TOWN OF APEX
APEX, NORTH CAROLINA
BIG BRANCH 2 PUMP STATION

Post Bid Negotiation

Post Bid Negotiation, Attachment 1

CIVIL
OVERALL SITE PLAN

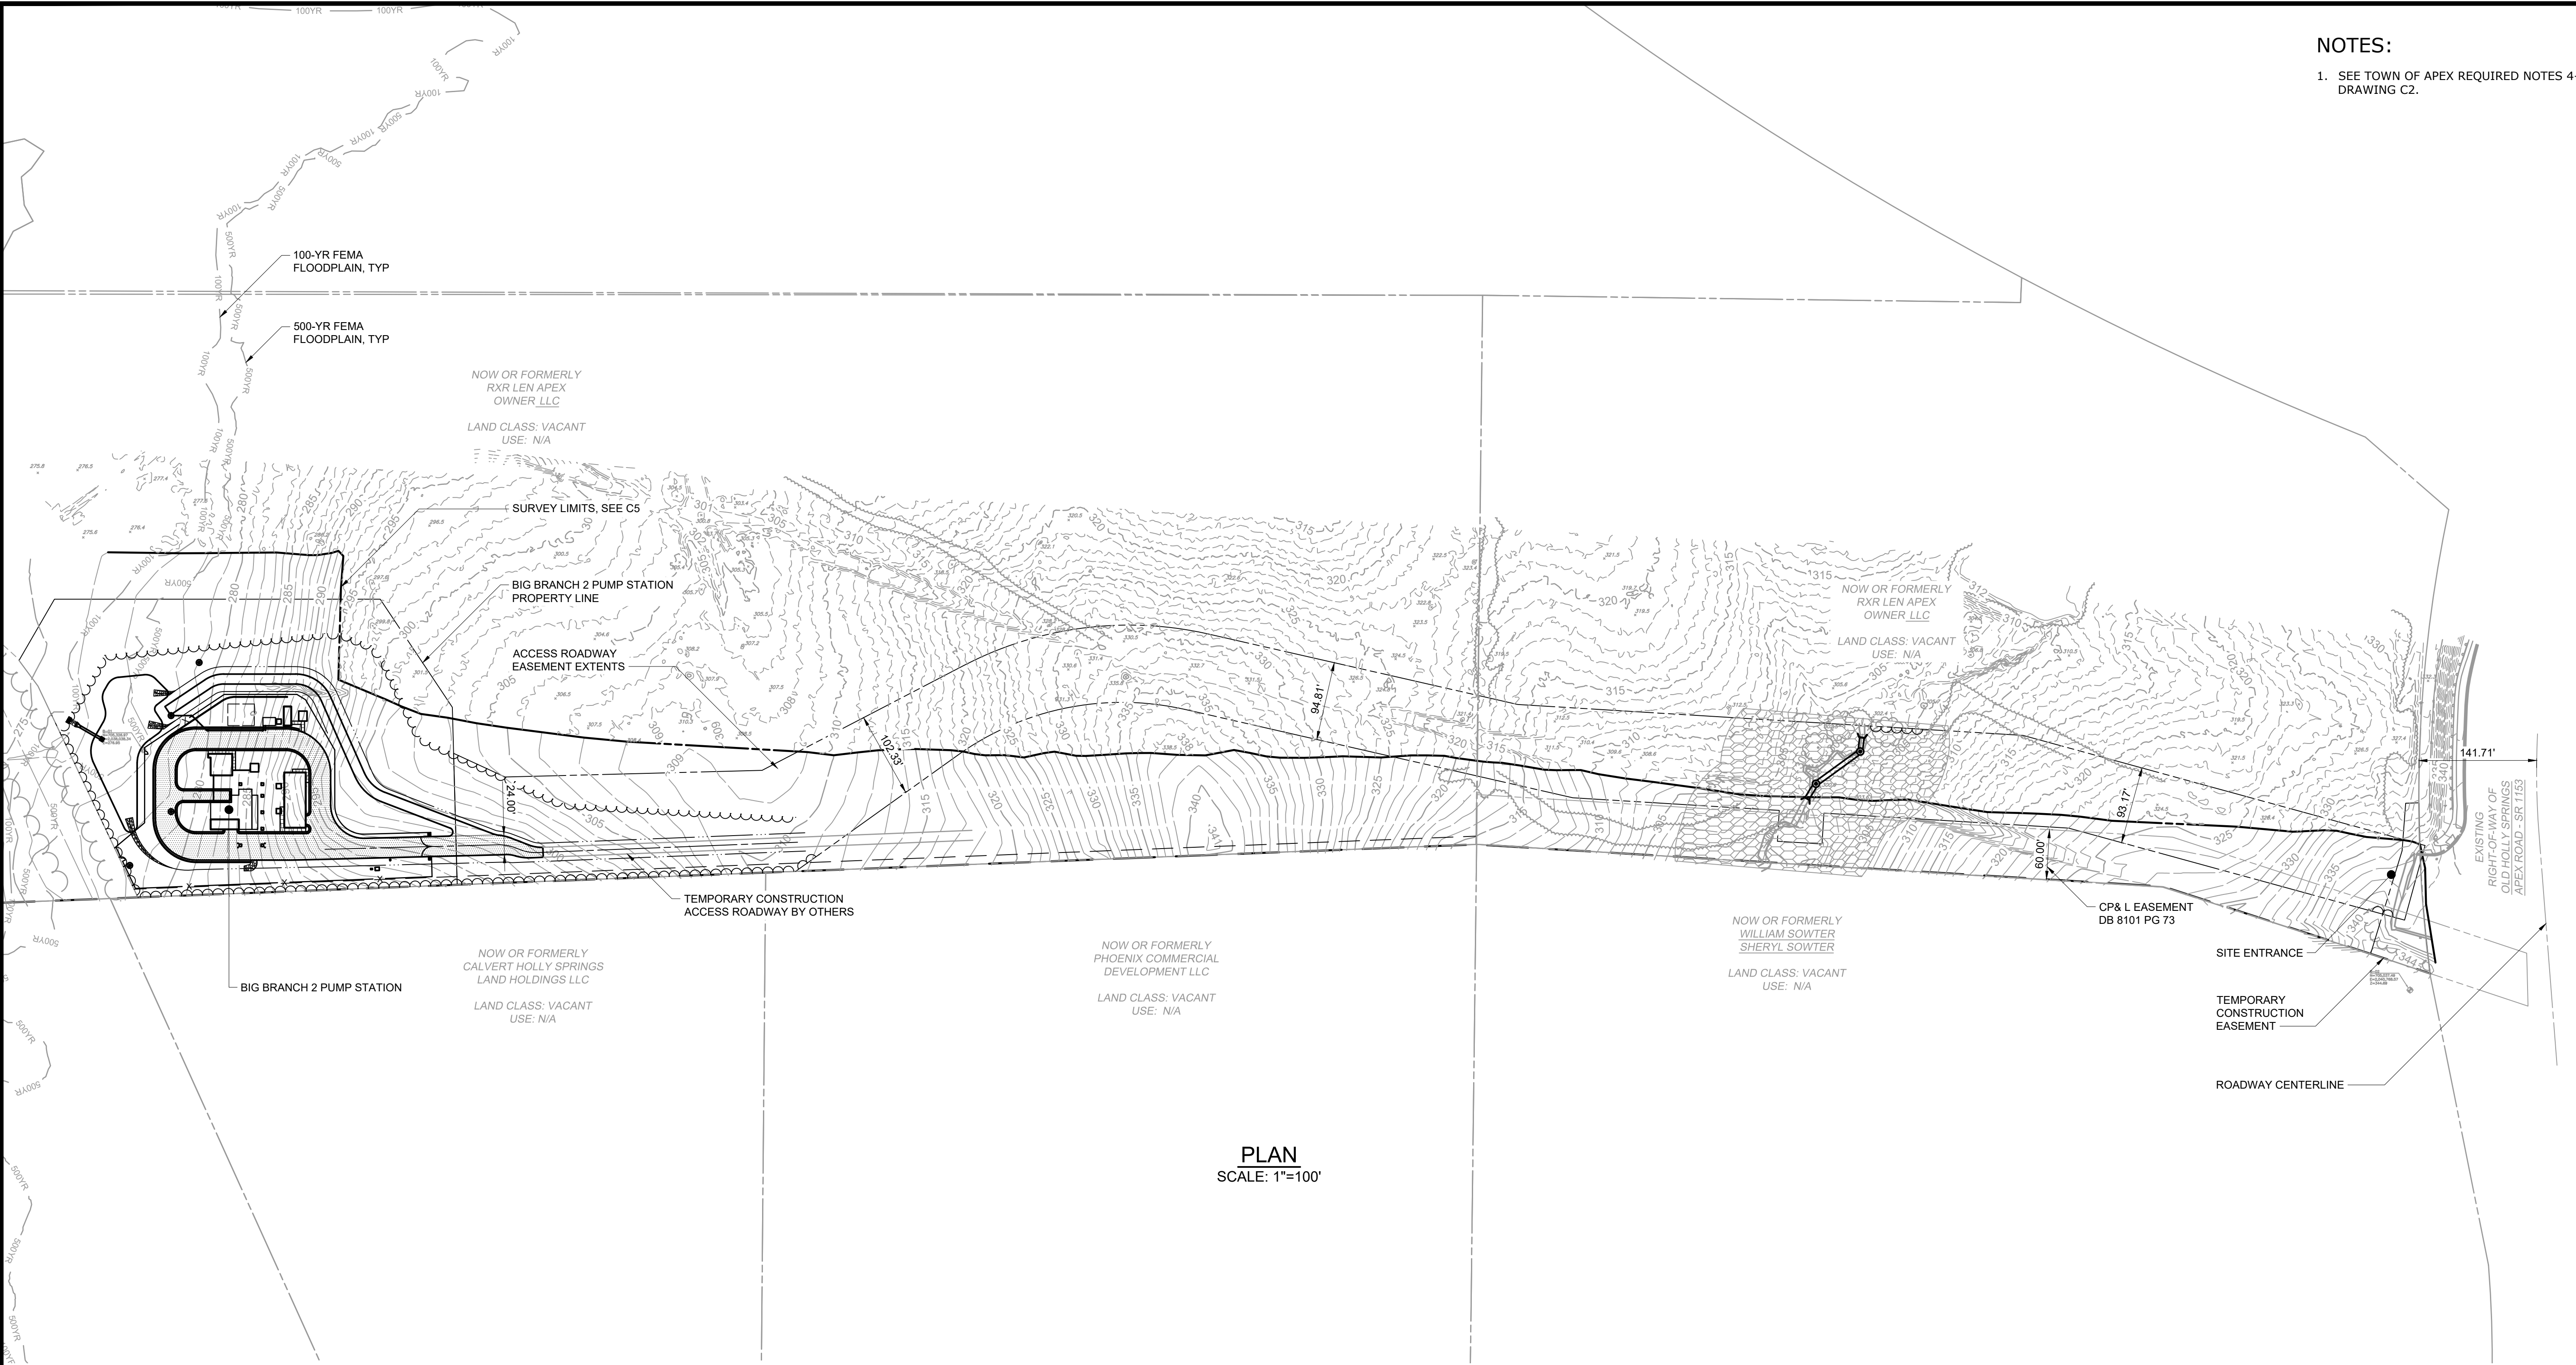
- Removal of the access road. The site will be accessed via the easement area that was cleared for the installation of the 20-inch force main and water main that was part of the Big Branch 1 Pump Station project. JCC will use the 12-foot gravel drive that will be constructed along the easement prior to Notice to Proceed. Upon completion of the project, JCC will restore the easement to seed/straw. Attachment 1 contains the revised grading plans.
